PROVISION OF LONG TERM REPAIR AND ENHANCEMENT WORK ON LOWER CANNOP POND DAM

My comments are limited to Lower Cannop Pond dam meantime. A recent satellite image of the dam is shown below. There is good access to the site from the west off New Road. The Forest of Dean Stone Firms Limited's facility extends from the west to about the mid-length of the dam. The section of dam in this area is now massive and I am not aware of any seepage or settlement issues on this part of the dam embankment. Moving eastward, the dam crest is also substantial but to a lesser extent and about 10m wide

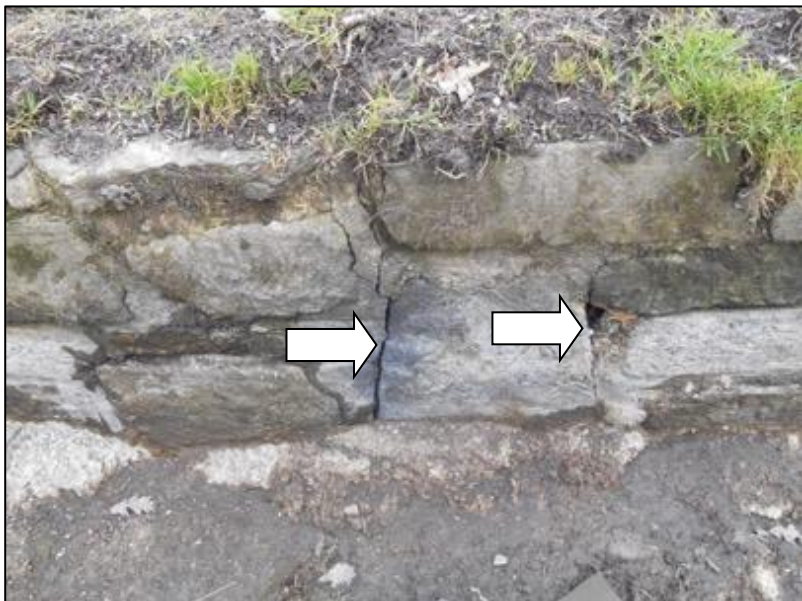
It appears to many people who object to any proposals to remove the dams, that since Andy Hughes' Report of 2021, Forestry England and their advisers have turned their backs on established dam repair techniques and seem intent on pursuing the "re-wilding" option whilst following an agenda to win over public support for this. **Why are alternative dam repair techniques not being considered and discussed with interested parties?**

APPENDIX 1

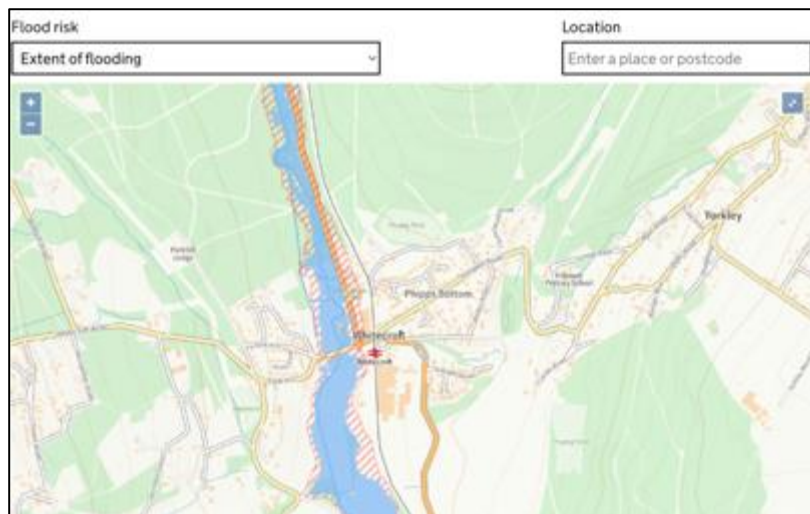
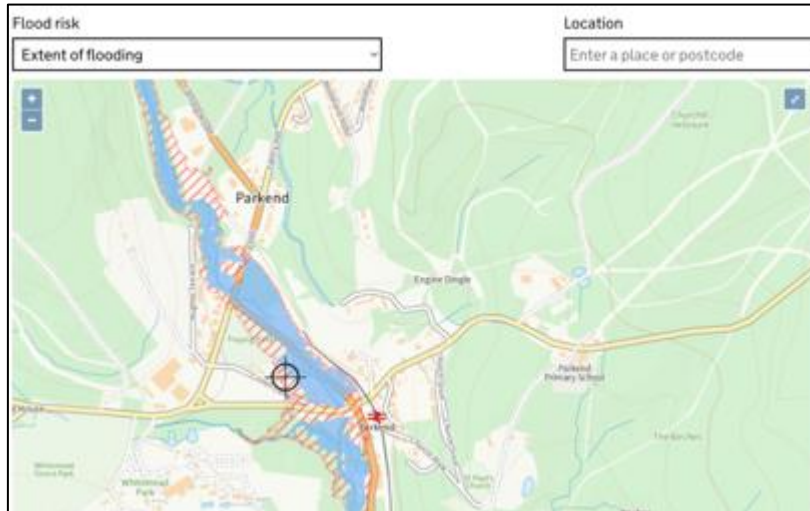
Some examples of flooded areas during dry days and wet days from a breach of the lower dam are shown in Appendix 1.

(blue shading signifies extent of flooding when river levels are normal and red hatching when there is also flooding from rivers.
